TOWN OF KITTERY

Planning Board Meeting February 8, 2023

ITEM 1—90 US Route 1—Major Site Plan — Preliminary Review

SITE LIGHTING PLAN

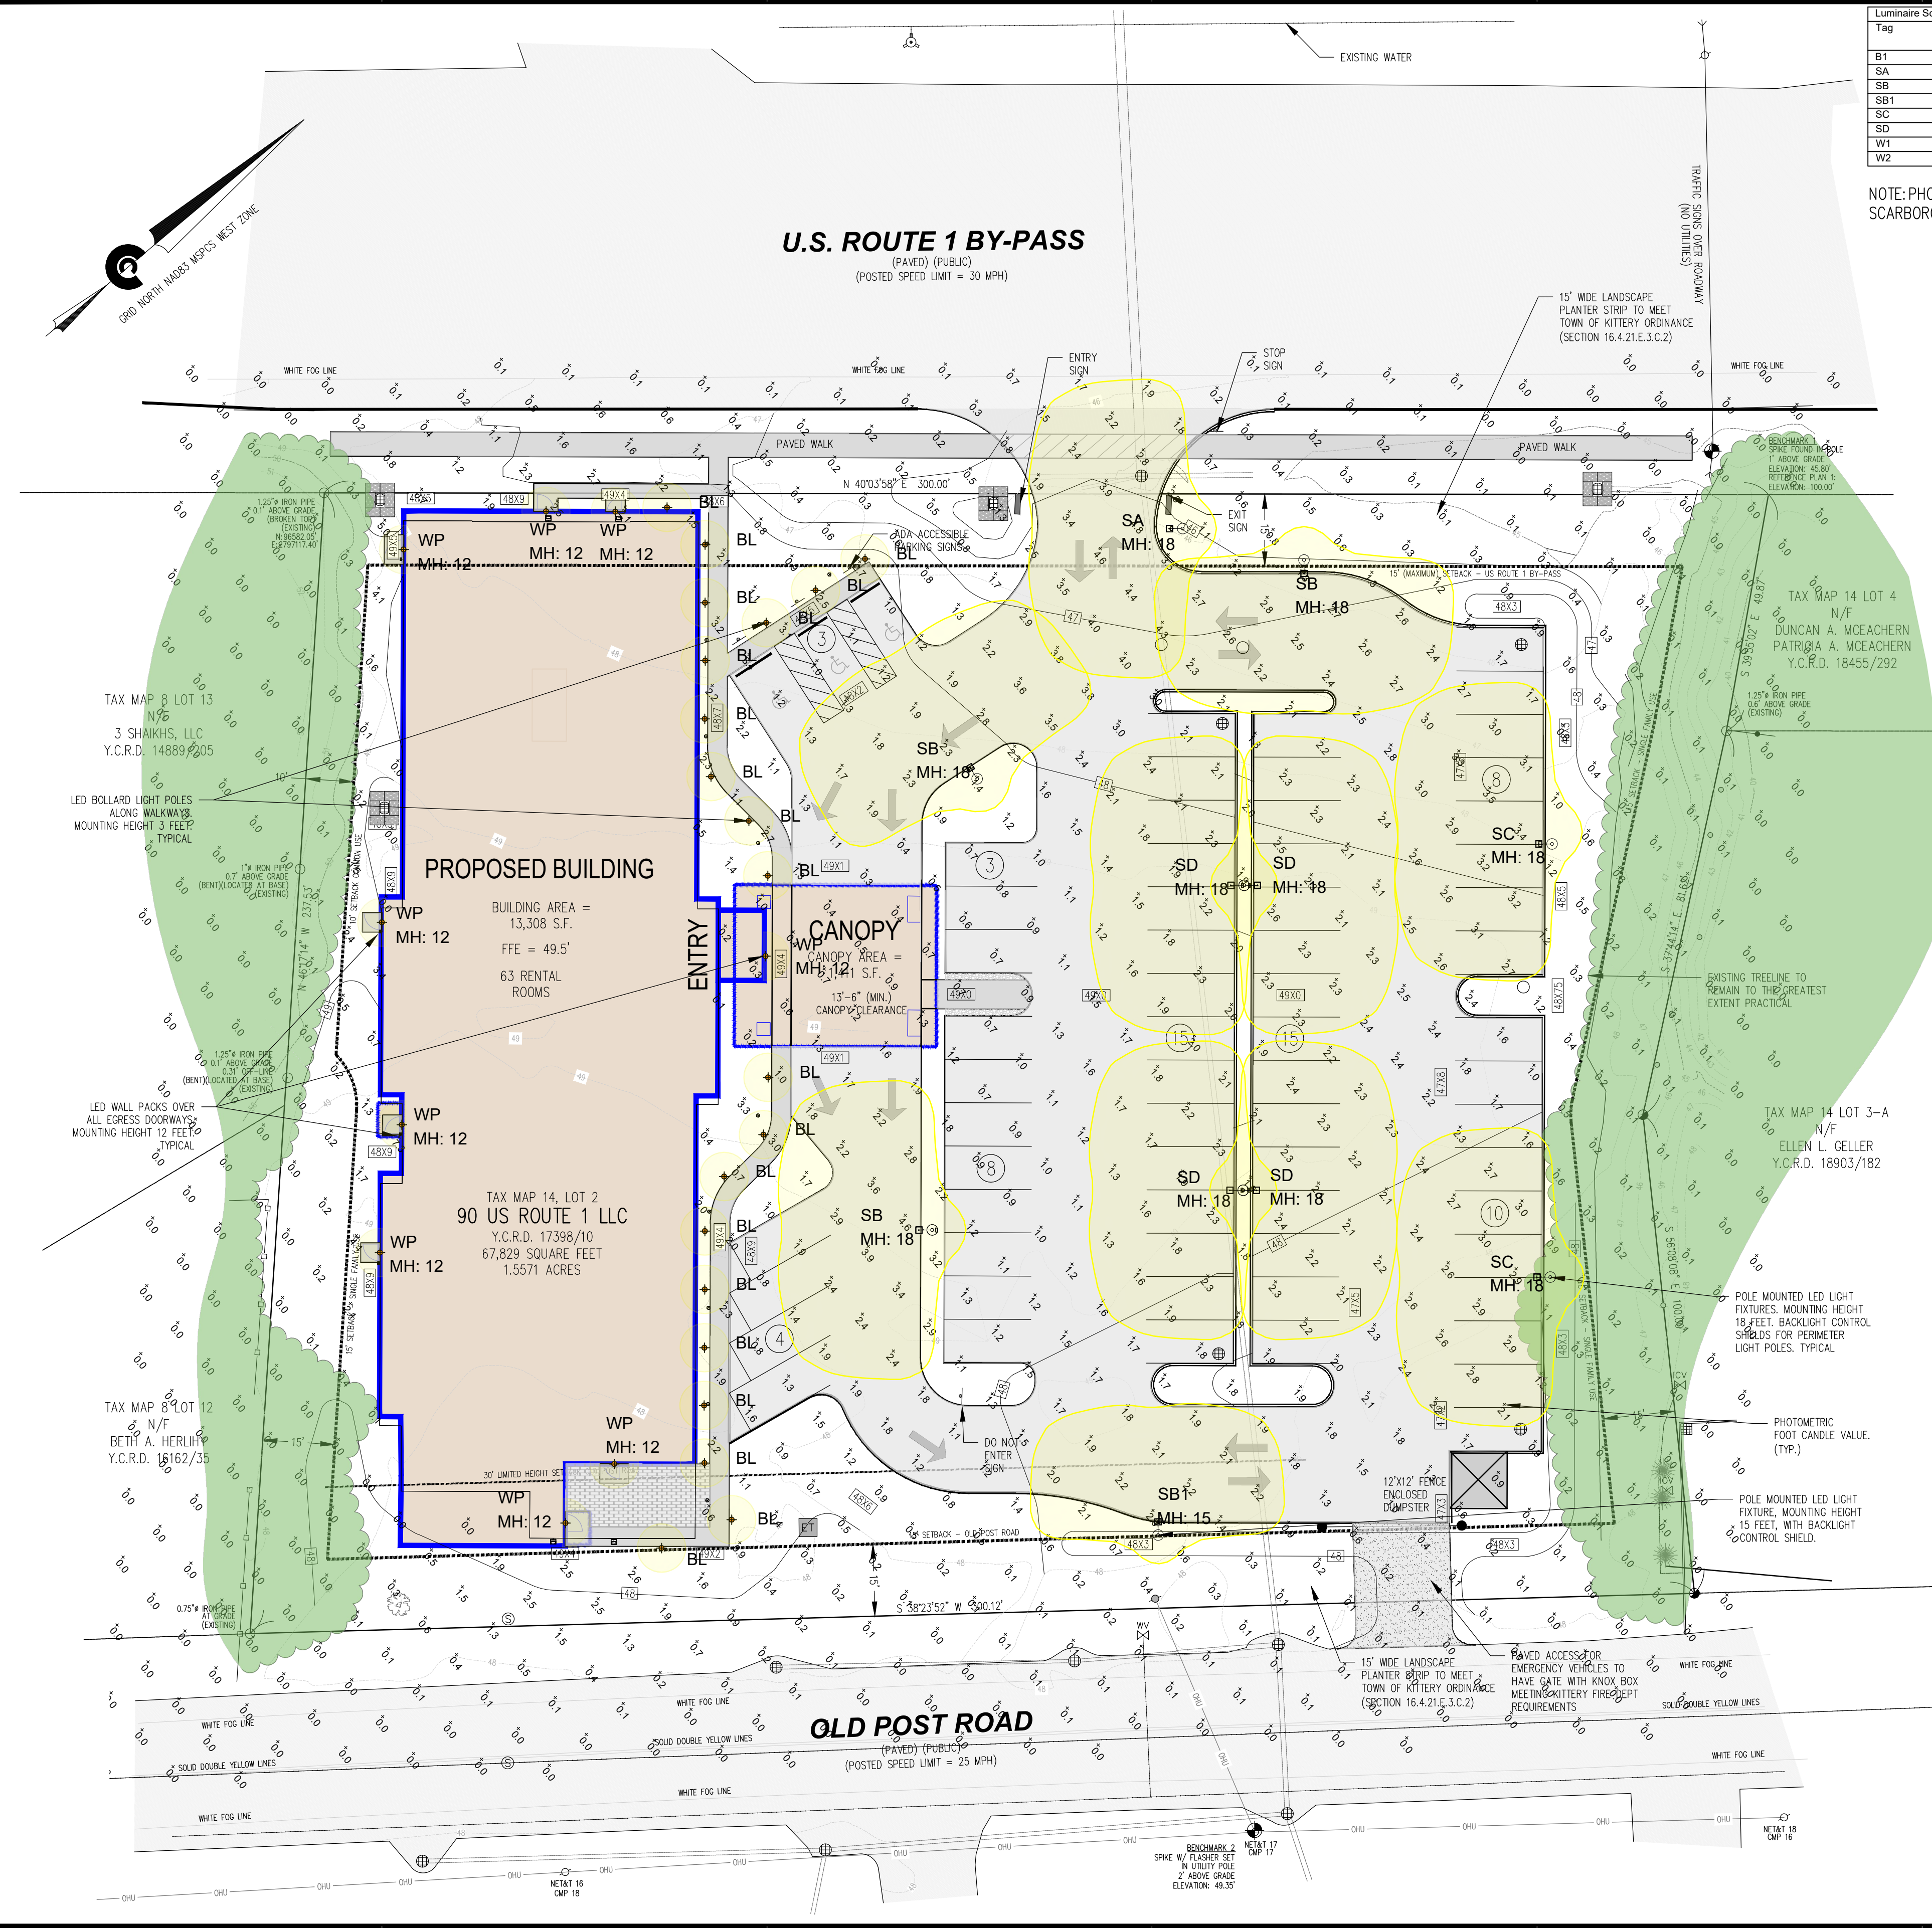
5. The engineer peer review found the current photometric plan caused glare beyond the property line on Old Post Road and the Route 1 Bypass site entrance. Future renditions of the lighting plan should remove this glare, or the applicant should request a waiver.

FIRST FLOOR PLAN

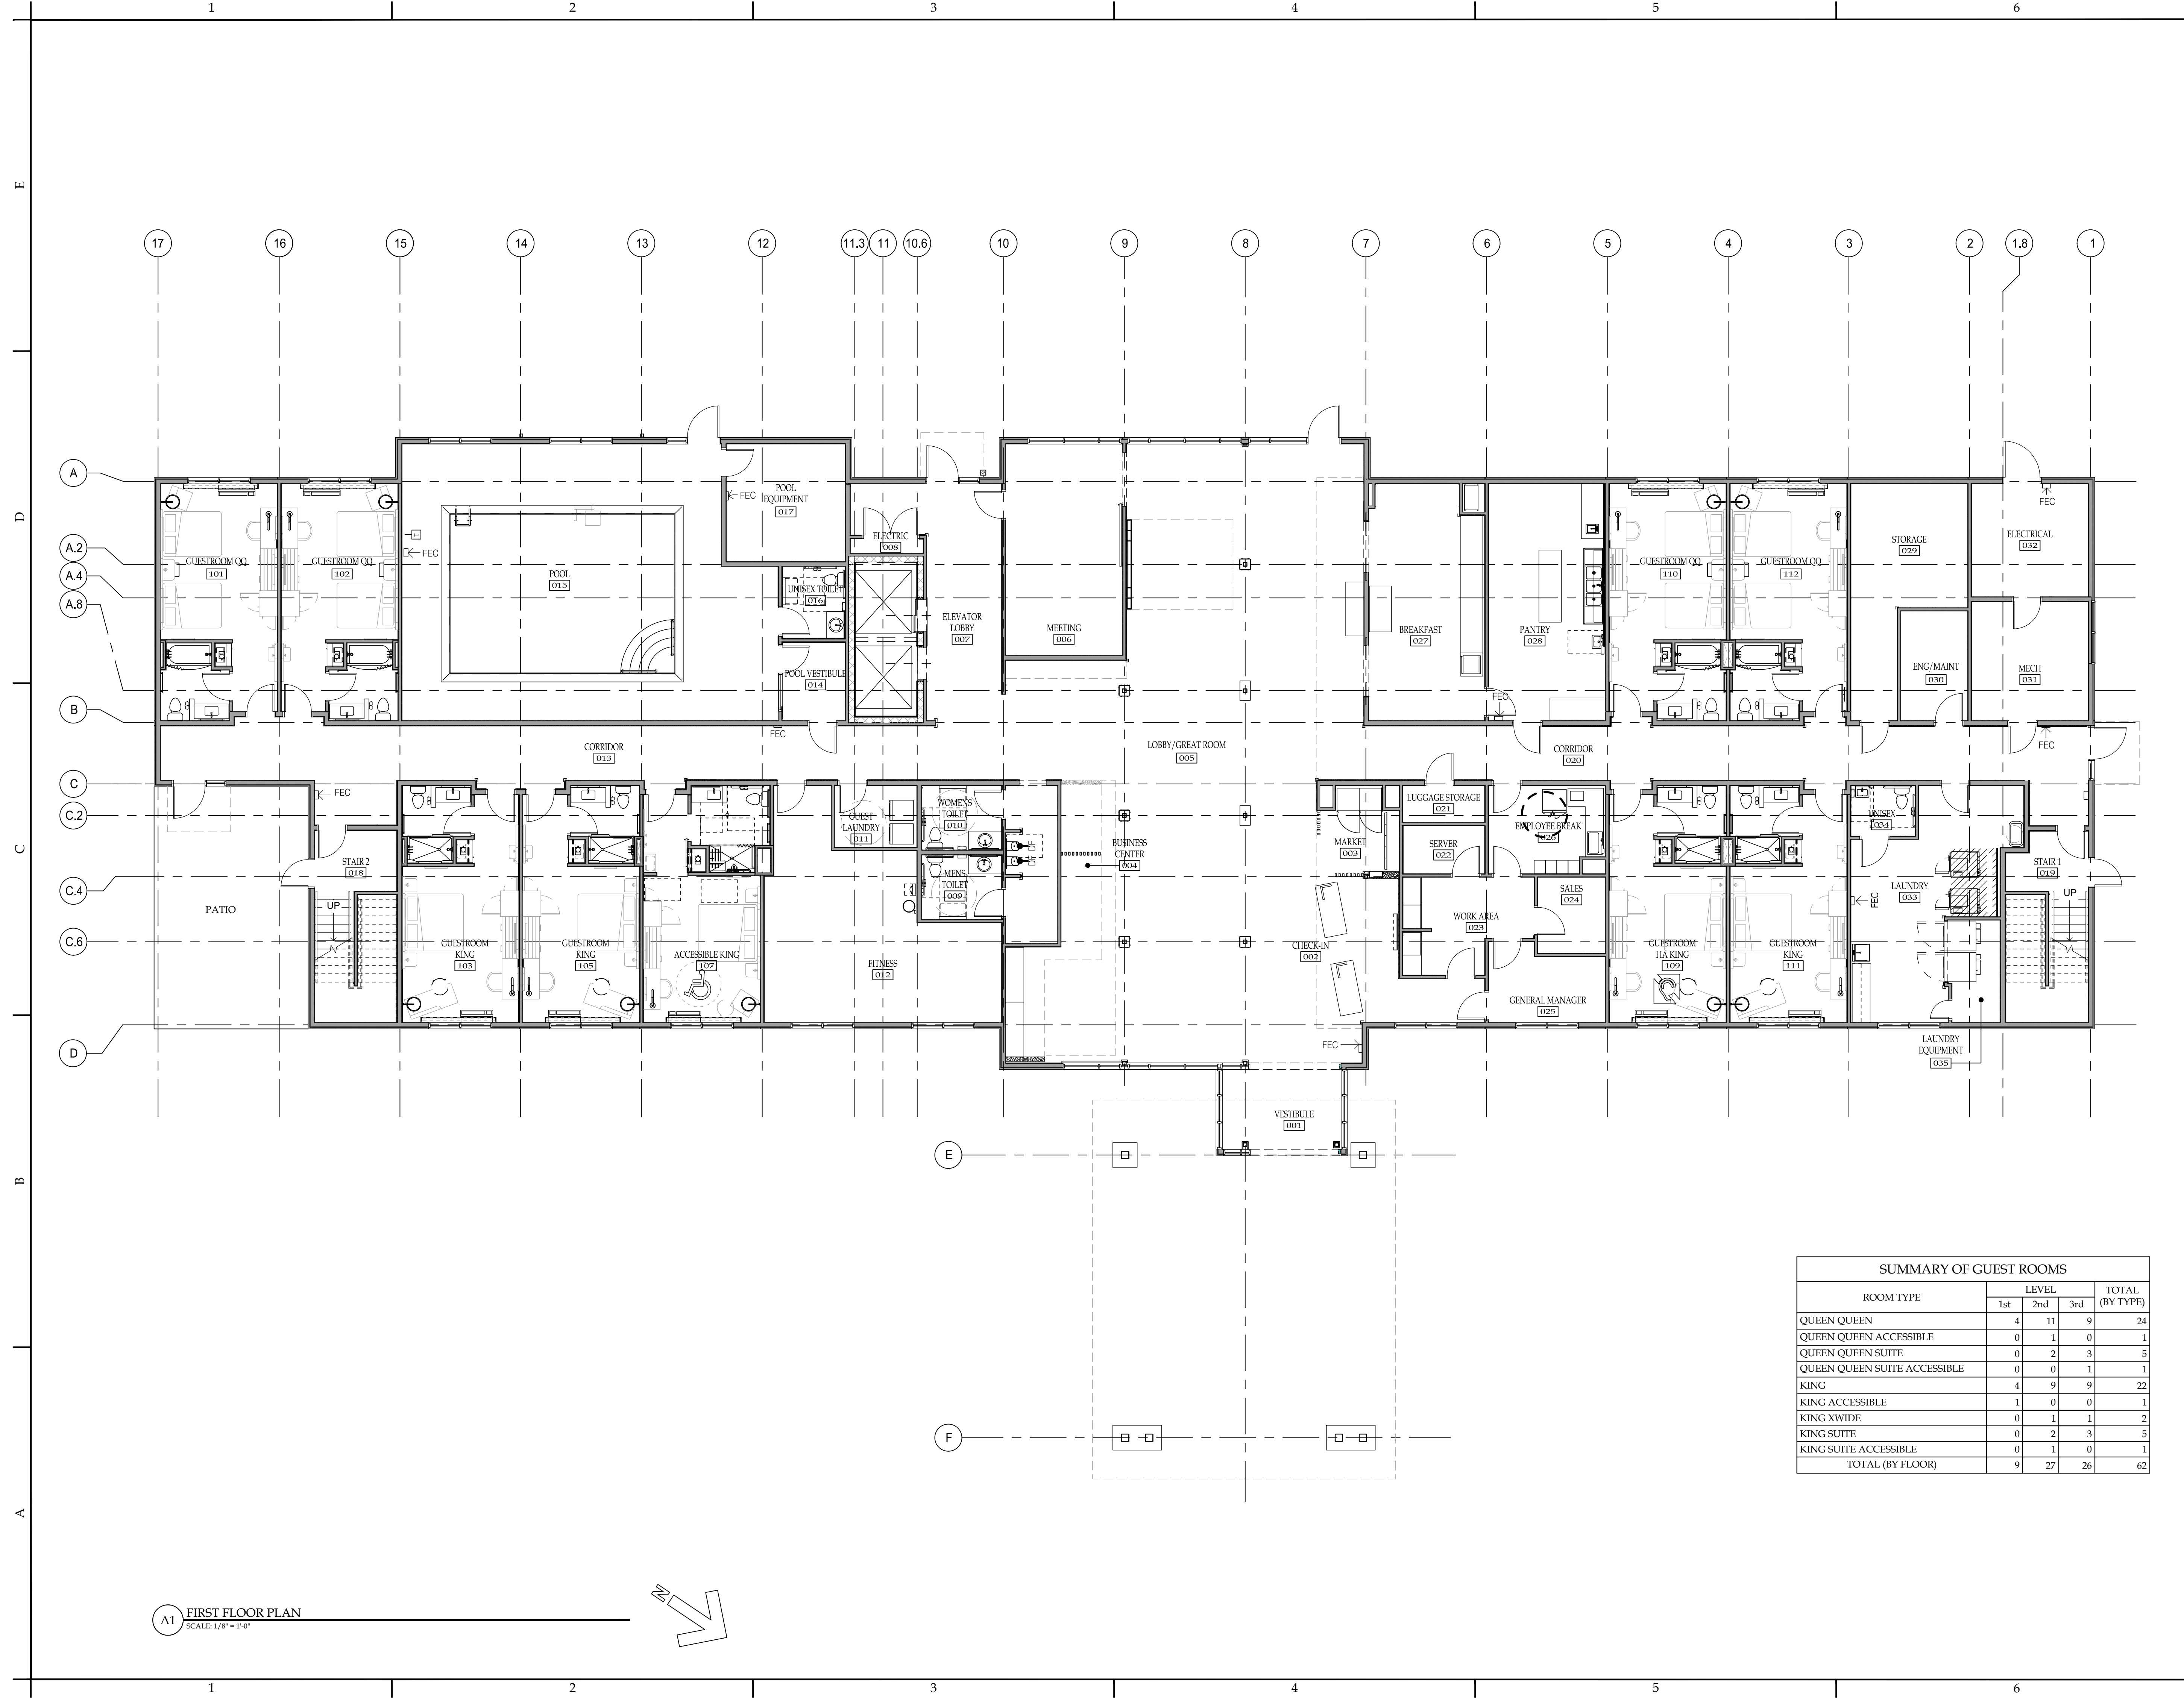
6. A fire truck turning movement plan will be needed as part of final review.
7. The architectural plan stated 62 rooms while the site plan says 63 rooms. The architecture plan should be amended to have the correct number.
